Re: Wallstrom Property Wetland Delineation & Classification Review
The Watershed Company Ref. No.: 120622.50

WALLSTROM RESIDENTIAL PROJECT

KIRKLAND, WASHINGTON

Re: Wallstrom Residence Buffer Modification, 2nd Review Letter

FIGURE #3
PROPOSED IMPACTS AND MITIGATION
WALLSTROM RESIDENCE
KIRKLAND, WASHINGTON

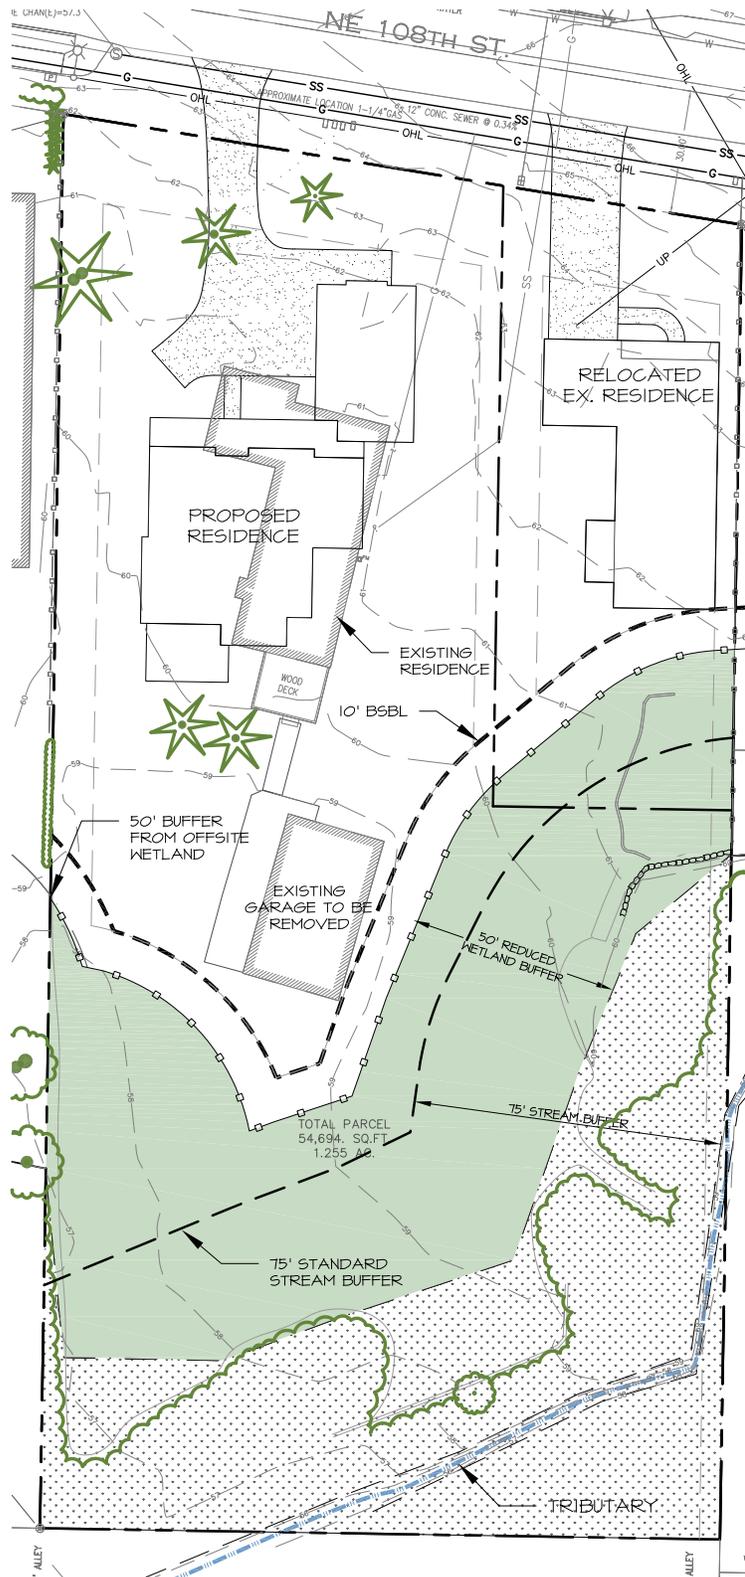
1. *Reduce the buffer reduction area such that it is the minimum necessary to allow for construction of the proposed single-family residence, and restore the reduced buffer at a minimum 1:1 ratio to the reduction area. It may be necessary for a very minor modification in the location and/or configuration of the proposed structure to maintain the 50-foot buffer and 10-foot BSBL.*

The current plan still depicts a meadow in the outer 10-30 feet of the reduced buffer. Since the entire buffer is currently mowed lawn, a meadow planted with native species represents only a slight improvement in buffer function, specifically water quality function. Current best available science indicates that a diversity of vegetation communities (forested, scrub-shrub, and emergent) is a desirable condition for wetland buffers. However, the CAR notes that the meadow area “will need to be mowed each fall to prevent the incursion of woody species.” Mowing of the lawn grasses is currently allowed as an ongoing activity, but with the land use change and associated buffer reduction and consistent with past approved buffer modifications, mowing inside of the wetland buffer should no longer be allowed. Furthermore, mowing the meadow area will severely limit the ability of the area to provide any protective functions in the rainy season, when water quality and hydrology functions are particularly important, and it creates a disturbance for wildlife, while also eliminating cover. The CAR continues, “Upon cessation of mowing, in the absence of natural wildfires, this meadow area would naturally evolve into a forested area, consistent with the typical climax community in this region.” Protective buffers are intended to naturally evolve in the absence of human intrusion or manipulation. If the applicant chooses to install a meadow in the outer portion of the reduced buffer (not allowed where the garden and fill pad will be removed), the area should not be subjected to mowing at any time. Natural succession should be allowed to occur uninhibited, with the exception of invasive species removal, as necessary.

The City has decided to allow reducing the standard 75-foot buffer to 50 feet across the entirety of the property, based on a similar determination for an adjacent property. The site plan has been substantially altered to prevent the need for stream buffer modification and paper fill. Generally, sufficient buffer restoration is proposed at more than a 1:1 ratio as mitigation for the buffer reduction area.

2015 Aerial View of Garden Area

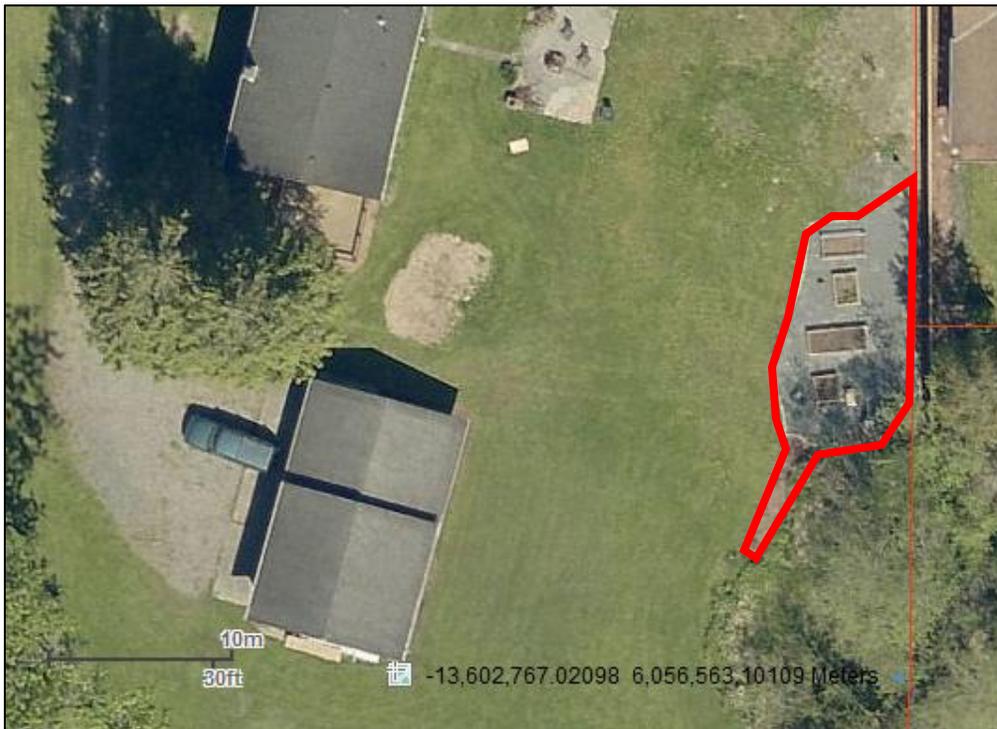
Since the garden is a violation, as part of a buffer reduction proposal, the garden and associated gravel fill pad should be removed, and the area should be restored with a native tree and shrub community. The garden may be relocated into other area on the property outside of the wetland and/or stream buffers.
